Dr Rivett Outline Response to Updated Statement of Common Ground and Jenny Lightfoot Proof of Evidence

Re: Appeal APP/M1900/W/21/3278097 (Nov. 2021) on rejection of proposed quarrying activity, Hatfield Aerodrome

BH305

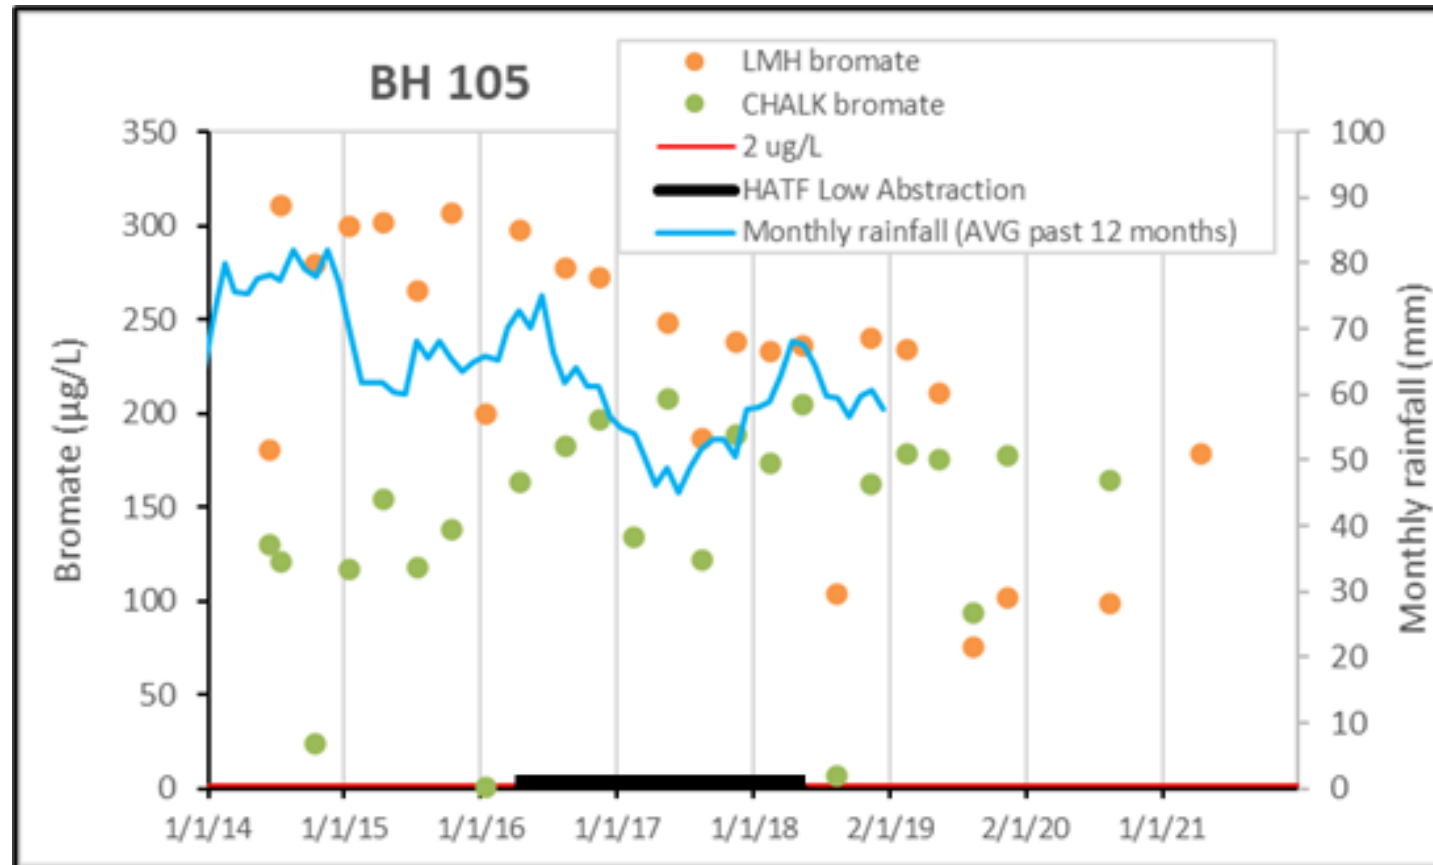
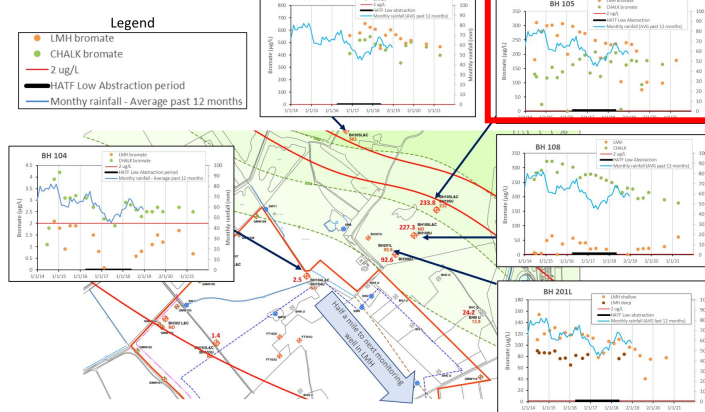
- Plume core area showing similar bromate concentrations in the LMH and chalk – hydraulic continuity between LMH and chalk possible
- LMH concentrations except once always greater than chalk
- Temporal variations show some similarity between LMH and Chalk
- Relationship to rainfall (limited data)
 - Not obvious for LMH
 - Possibly for Chalk – lower bromate in wetter period
- Relationship to HATF low abstraction:
 - LMH Bromate possibly declines with increased abstraction after

BH105

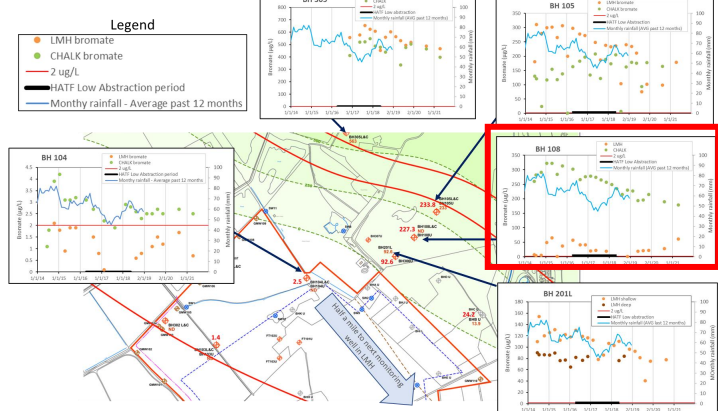
- Until recently LMH concentrations usually higher than Chalk, can be around double
- Trends are notably different in LMH and chalk –not suggest local hydraulic continuity between LMH and Chalk
- Relationship to rainfall
 - Not obvious for LMH
 - Not obvious for Chalk (?)
- Relationship to HATF low abstraction:
 - LMH Bromate tends to decline (?)
 - Chalk bromate tends to increase (?)
- Recent period – rather confusing unclear relationships

BH108

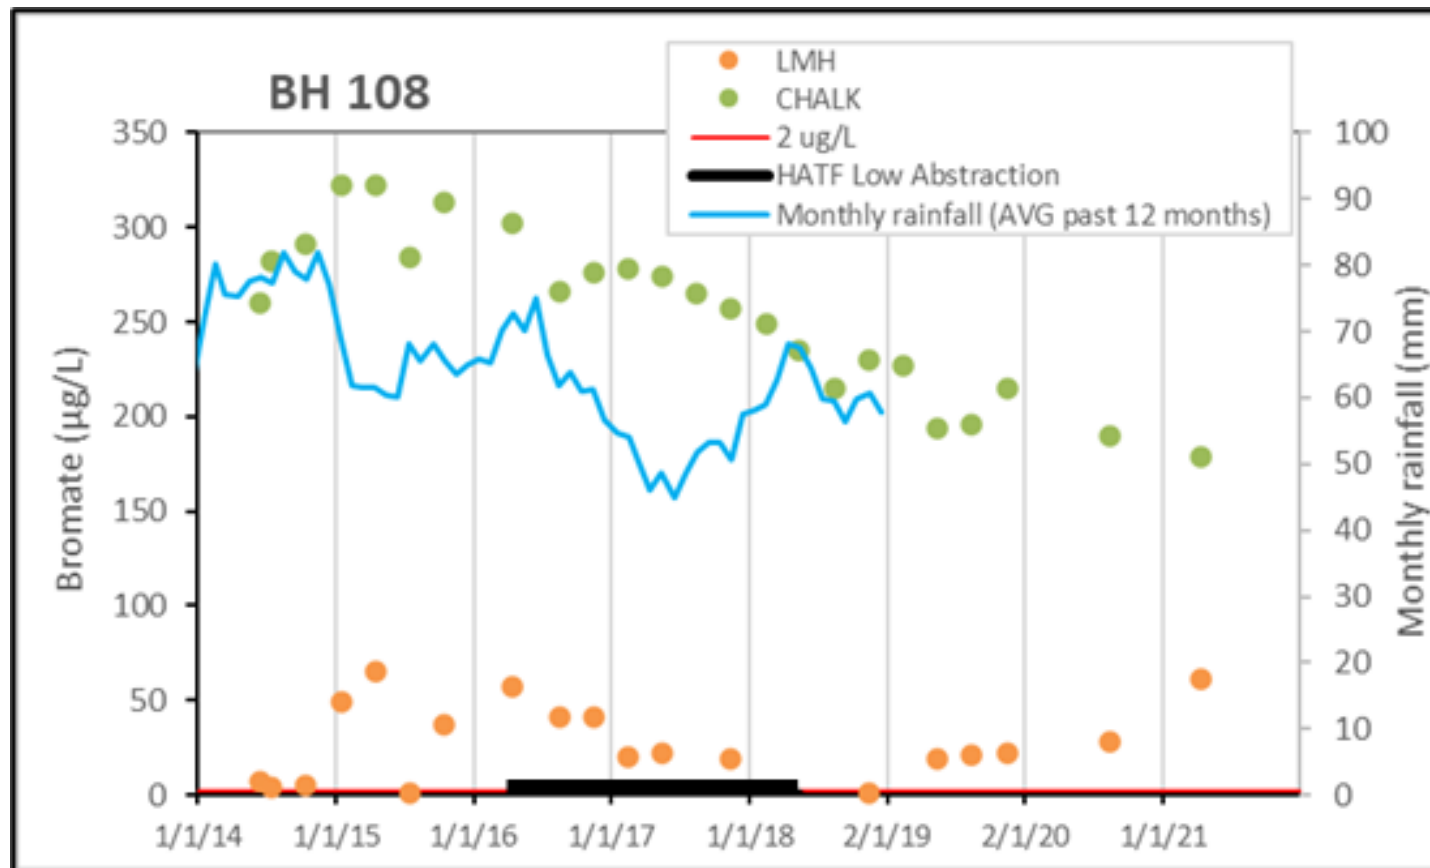
- LMH bromate appears anomalously low compared to the chalk compared to other boreholes
- Chalk shows a declining trend overall that is not shown by the bromate – recently bromate is increasing as chalk declines

- Bromate concentrations do not fit trend of adjacent lateral boreholes spatially (201 L data higher bromate)
- Trends are notably different in LMH and chalk – not suggest local hydraulic continuity between LMH and Chalk

- Relationship to rainfall
 - Not so obvious for LMH, possibly earlier period shows increased bromate in drier years
 - Possibly for Chalk – some higher bromate in drier years (?)

- Relationship to HATF low abstraction:
 - Chalk – not obvious against other trends(?)
 - LMH – **yes**: Bromate appears to gradually decline during abstraction low followed by a gradual increase over 2 to 3 years back to pre low-abstraction period concentrations as pumping increased. This may be very reasonably interpreted as a SLOW lateral drift of the plume transversely across 108 back and forth away from and then towards the Site.

- LMH behaviour is very distinct from Chalk

BH201L

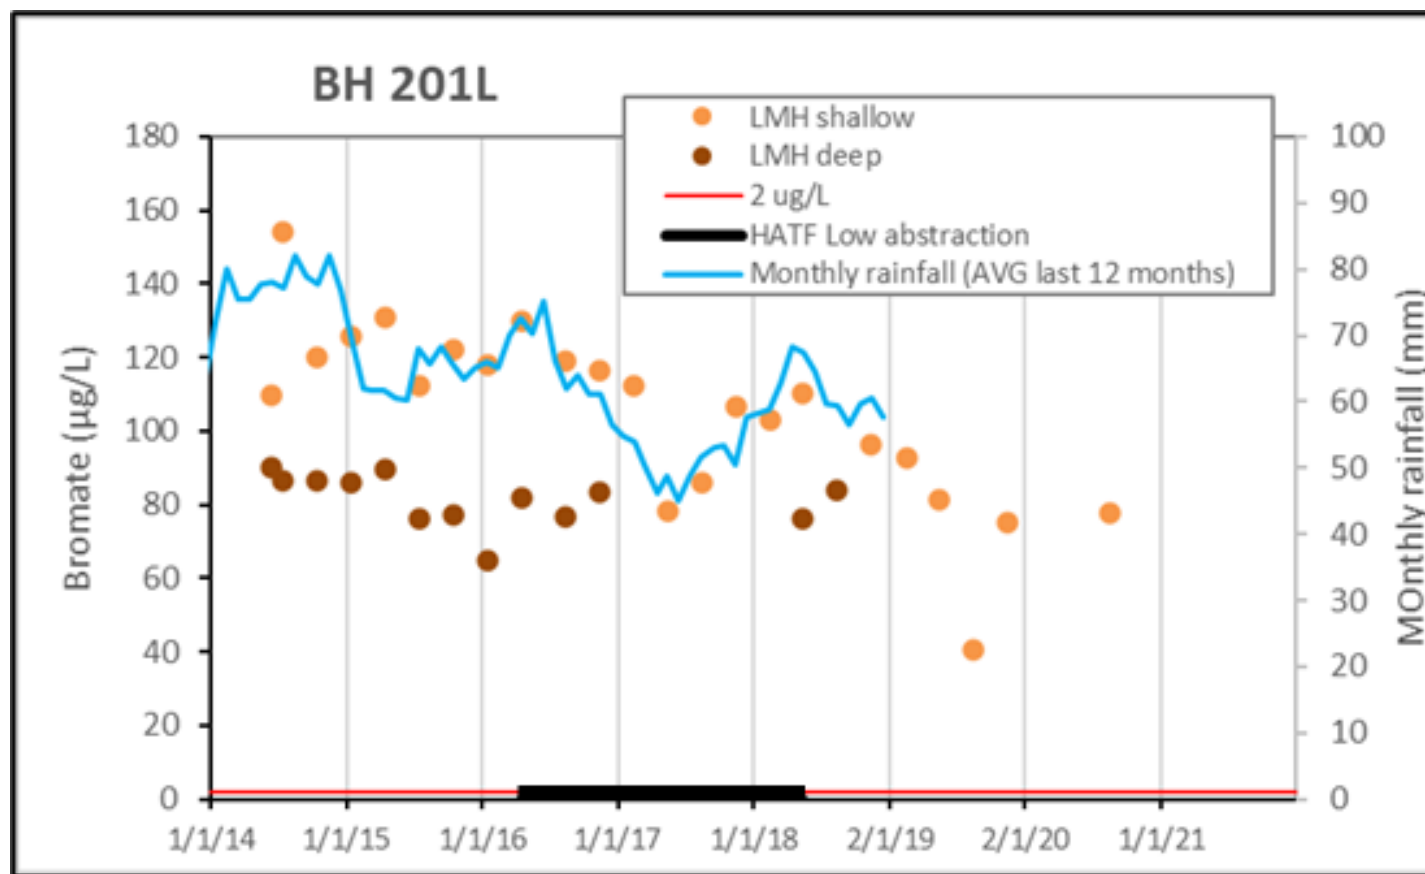
- Comparison here is of shallower and deeper points in the LMH (and not with chalk)
- The borehole is very close to the Site perimeter and shows much higher concentrations around 100 ug/L bromate than Borehole 108 considered above laterally close to the plume core. Hence shows heterogeneity of plume edge and issues with the half-a-mile gap in the monitoring

- Bromate in the shallow LMH is consistently higher and more variable than the bromate in the deeper LMH – showing the importance of higher shallow contamination in the LMH

- Together they suggest high bromate concentrations over the LMH thickness around 50 times the 2 ug/l plume threshold that is very close to site and highly likely to be pulled in to Site by quarry abstraction in the LMH

- Deeper LMH shows quite constant bromate and contrasts with the shallow LMH bromate that shows declining bromate with time
- Relationship to rainfall
 - Not obvious for deeper LMH

- **Yes – for shallow LMH – there appears good correlation with the rainfall trend with increased bromate observed with increased rainfall – this would suggest increased leaching of shallow source area bromate with increased rainfall and water levels – it shows the importance of the LMH gravels receiving such contamination from the Chalk extremely close to the quarry site at very high concentrations**

- Relationship to HATF low abstraction:
 - Deeper LMH – not obvious
 - Shallow LMH not obvious against other trends

BH104

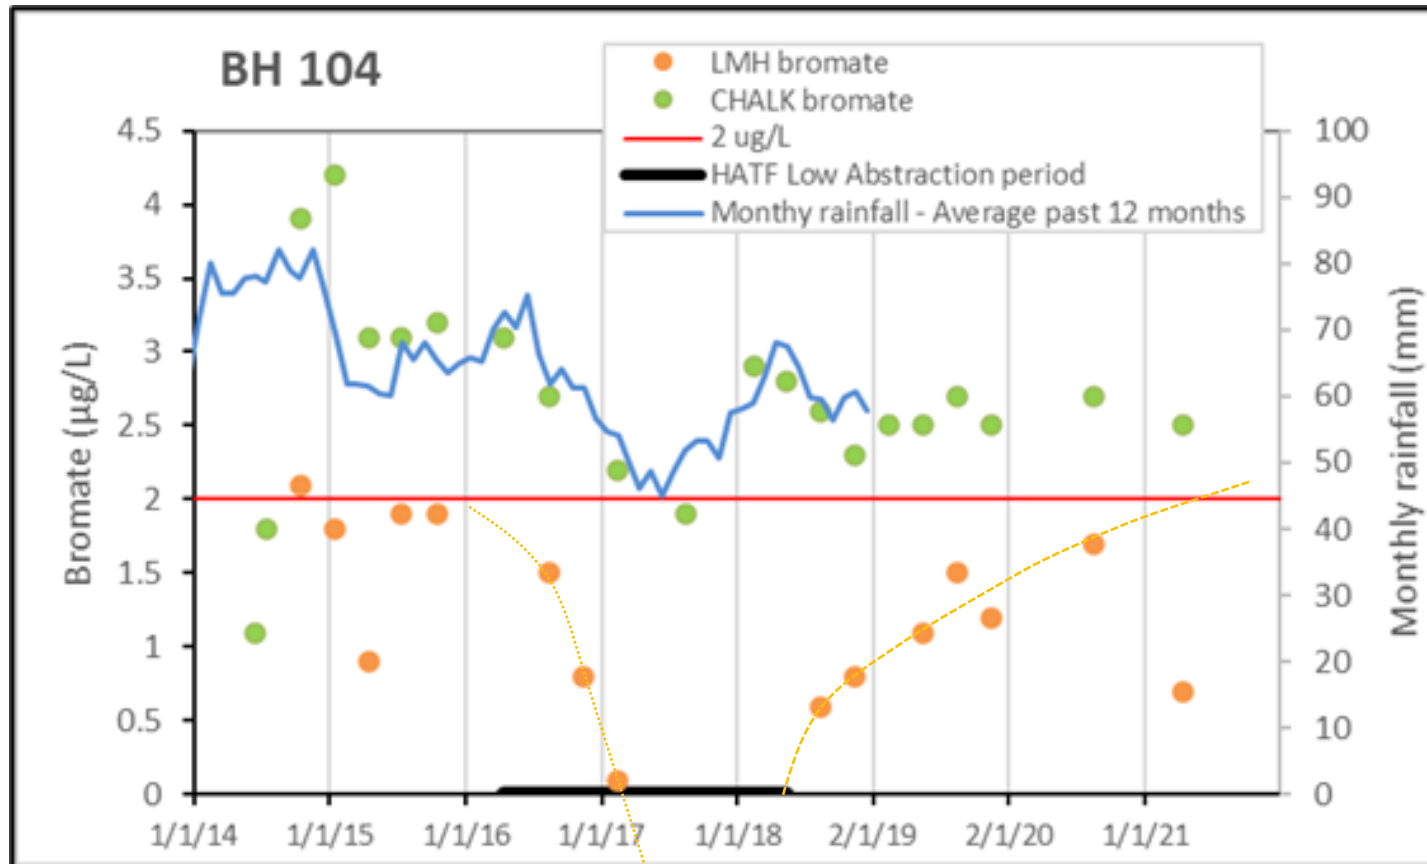
- Boreholes at site NE corner perimeter
- Chalk bromate at 2 – 4 ug/l just above plume threshold
- LMH bromate usually below but may approach 2 ug/L threshold

- Trends are notably different in LMH and chalk –not suggest local hydraulic continuity between LMH and Chalk
- Relationship to rainfall
 - Not obvious for LMH

- Yes – very obvious for chalk bromate with higher rainfall and higher water levels having higher bromate suggesting again the importance of leaching shallow source zones of bromate at high water table

- Relationship to HATF low abstraction:
 - Chalk not obvious
 - LMH Bromate – Yes, similar to 108. Bromate appears to gradually decline during abstraction low followed by a **gradual increase over 2 to 3 years back to pre low-abstraction period concentrations as pumping increased**. This may be very reasonably interpreted as a SLOW lateral drift of the plume transversely across 108 back and forth away from and then towards the Site.

- LMH behaviour is very distinct from Chalk

LMH / Chalk Bromate ratio – not stabilised?

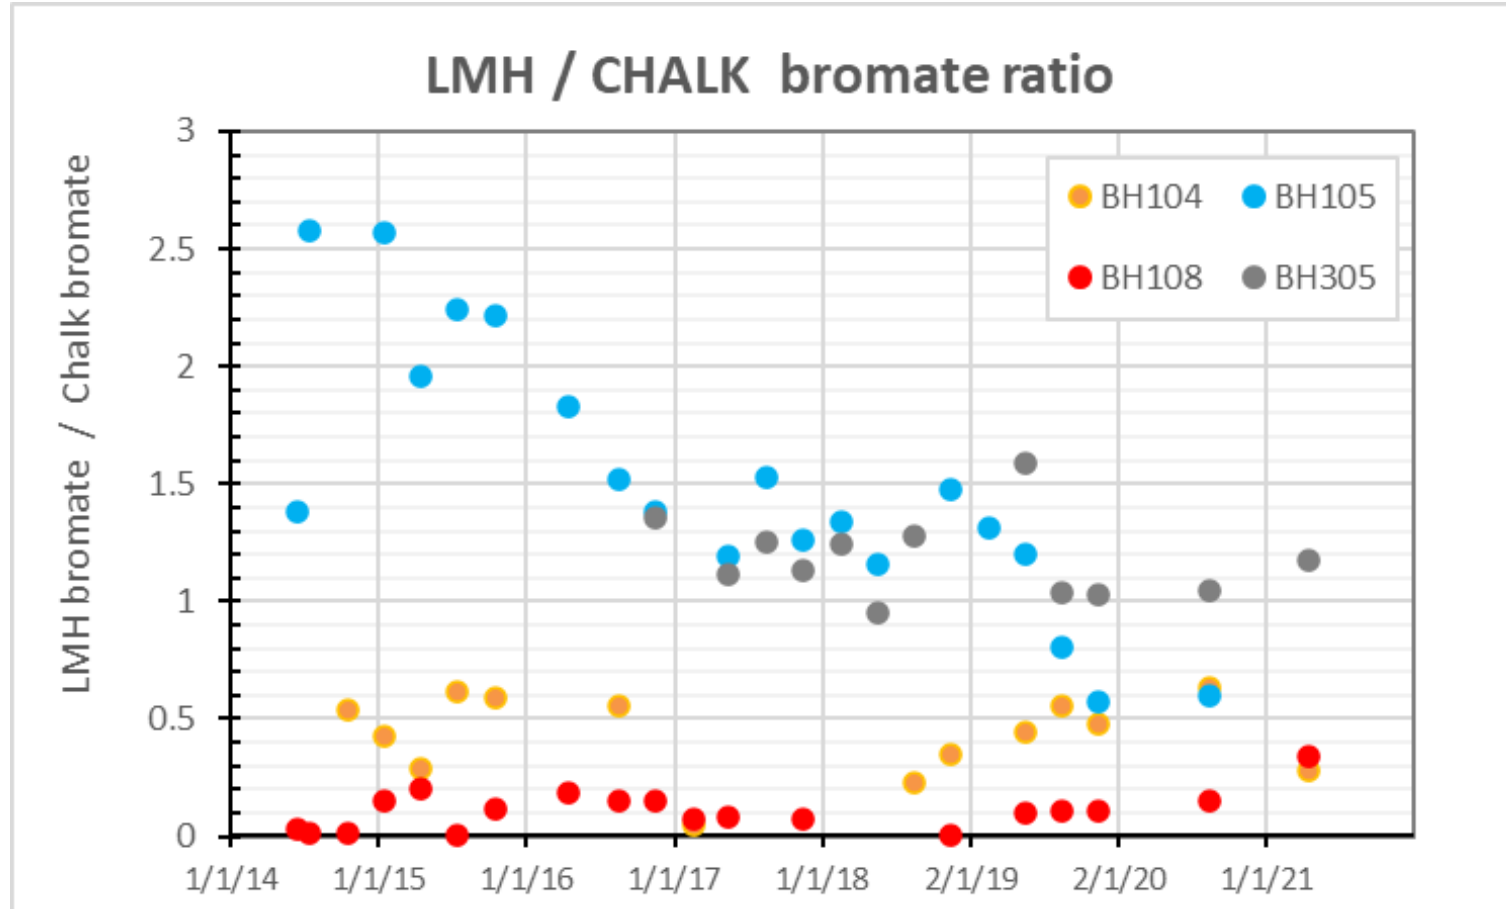
In fact, since 2018 when the HATF abstraction became more stable at c4.5MI/d, the bromate ratio between LMA and Chalk has stabilised, indicating that a steady state condition has been reached with fixed leakage between LMA and Chalk.

- The ratio of LMH Bromate / Chalk bromate does not look as stable as the SoCG suggests?
- There are quite a lot of factors controlling this ratio evidenced by the spatial and temporal variability in these ratio
- These ratio are important and need to be understood better at the local and regional levels to help understand the chalk and LMH plume relationships in space and time

- What is the percentage of bromate abstracted from:
 - the Chalk-LMH-Chalk pathway
 - versus Chalk only pathway

Statement of Common Ground

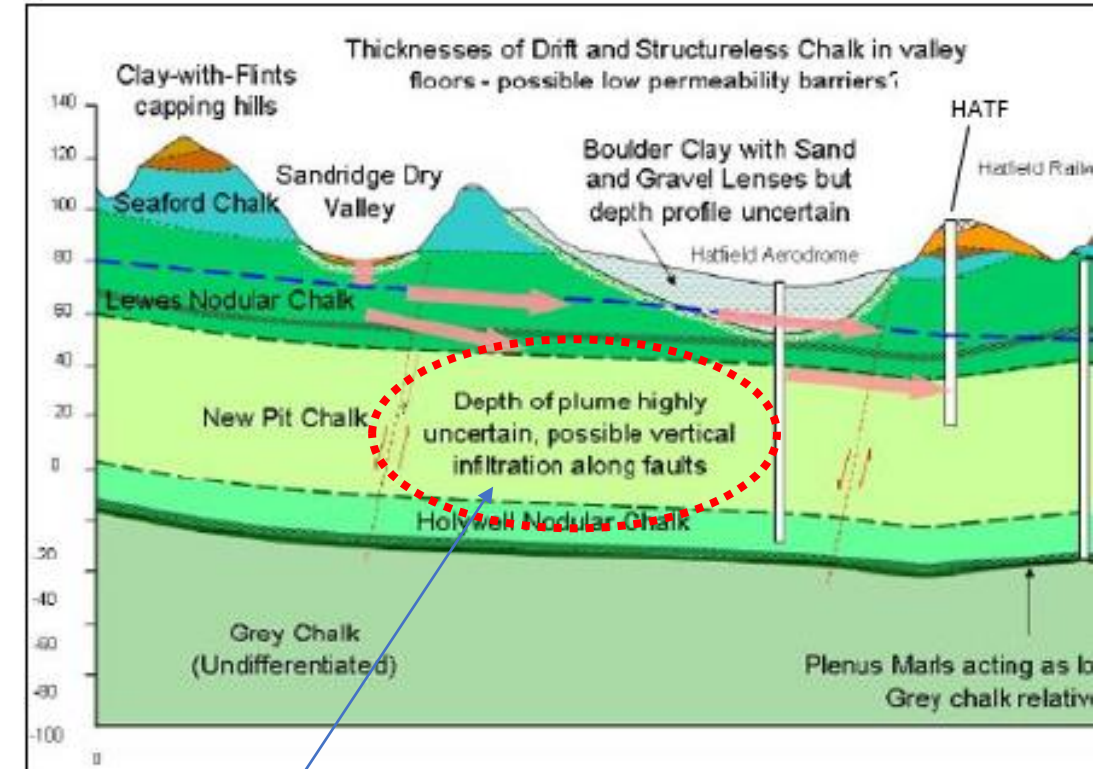
- 4.2
- The HATF abstraction location is at a higher elevation (102mAOD) than the proposed quarry site, and at some distance from the paleochannel (Figure 6). HATF boreholes are screened into and abstract from the Chalk at a total depth of c.100m (2mAOD), connected via adits spanning up to 174m at a depth of 82m (20mAOD). Adits were typically dug in the past to enhance the capture zone of a borehole, enlarging yield in the most productive part of the aquifer.
- This suggests that the HATF abstraction receives most of its bromate rich water at depth within the Chalk aquifer (i.e where the adits are located). These depths contrast with the top of the Chalk beneath the proposed quarry (60-63mAOD), which is approximately 40m above the adit elevation.

- To NOTE
- BUT, is the inference here somewhat misleading?
- The bromate in both the LMH and shallower chalk in the capture zone migrating towards HATF will ultimately drain down into the adit system and be abstracted by HATF?

Statement of Common Ground 4.1 (part of)

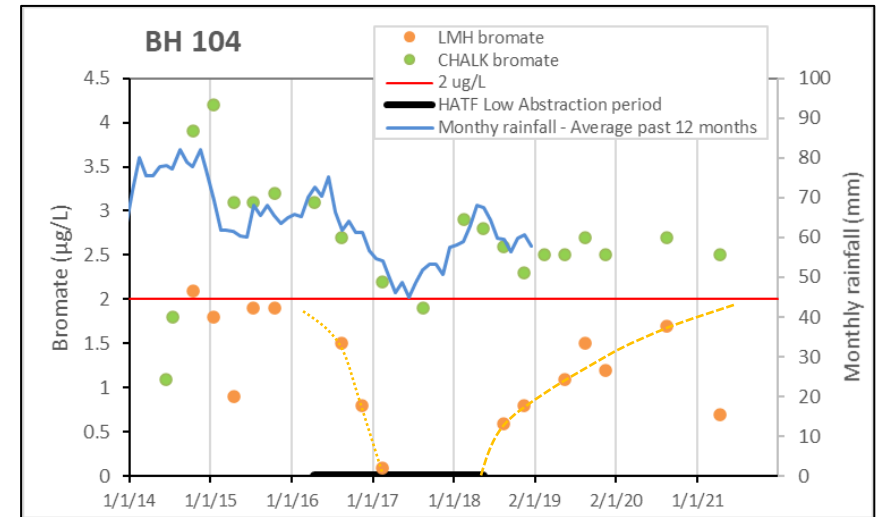
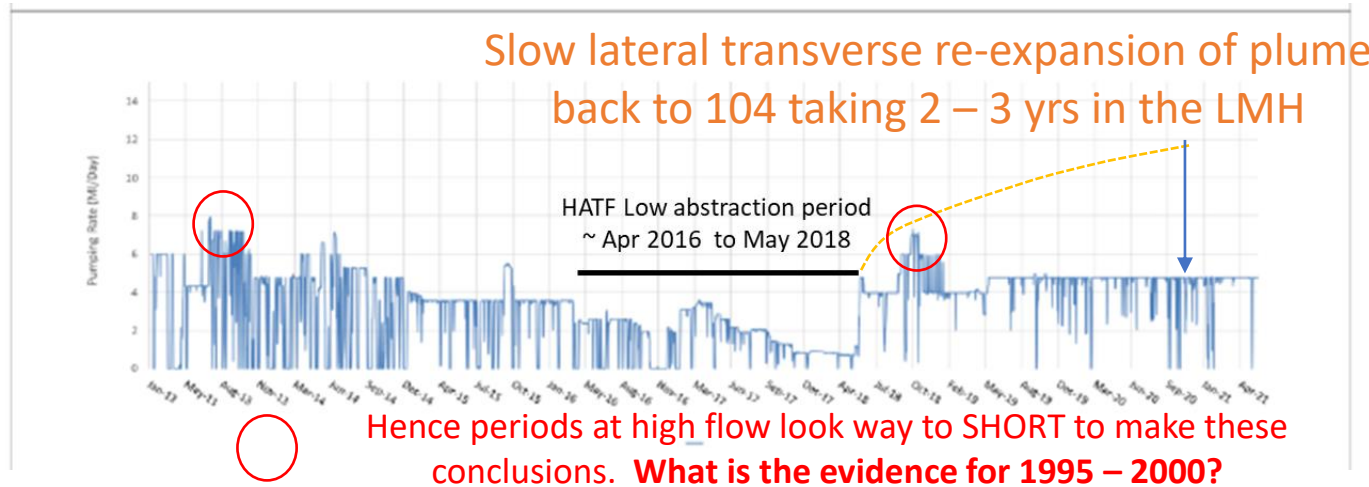
- Under low pumping at HATF the southern boundary of the plume moves north, while higher pumping rates cause this boundary to move south. **However, even under scenarios where HATF has pumped at or near its maximum licensed volume (9ML/d, in the past between 1995 and 2000 and more recently in 2013/14 and 2018), the southern plume boundary has been shown not to move onto the proposed quarry site.**

- My response: The 2013/14 and 2018 conclusion looks in error.** BH 104 trends in the LMH strongly suggest that there is slow, lateral transverse re-expansion of plume in the LMH. It is slow as the movement is perpendicular to main flowline to HATF and also sideways motion in the high storage gravel will be slower than the chalk and also it is at distance from the adits) . **Pumping rates at 9 ML/d would have to be tested for far longer** to see this plume movement. The monitoring evidence has not been provided for the 1995-2000 period that would be important.
